Access Compliance Report

Public Rights-of-Way

(Pedestrian Signals)

Intersection ID: N/A	Main Street:	Cross Street: N/A	Location: N/A
ADA ID: 2D69D8CAC95B	Signal Type: One Push Button-APS	Overall Compliance: No	Severity Score: BTN 1: N/A BTN 2: N/A No BTN: N/A
Codes/Mitigation Info/Possible Solution		Field Measurements/Component Compliance

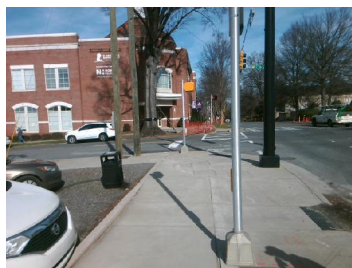
PROW/ADA: TMUTCD 4e.08, R404.2, R209.1, MUTCD 4e.10

Yes	B 1 Clear Xing Direction?	ClearlyMarked	N/A	B 2 Clear Xing Direction?	N/A
	B 1 Crossing Direction	To SE		B 2 Crossing Direction	N/A
Yes	B 1 DistanceTo XWalk (in)	10.0	N/A	B 2 DistanceTo XWalk (in)	N/A
No	B 1 DistanceTo Curb (in)	91.0	N/A	B 2 DistanceTo Curb (in)	N/A
Yes	B 1 Diameter (in)	2.0	N/A	B 2 Diameter (in)	N/A

Possible Solutions: Replace Signal Push Button With APS Button on New Post. Remove & Relocate Sign.
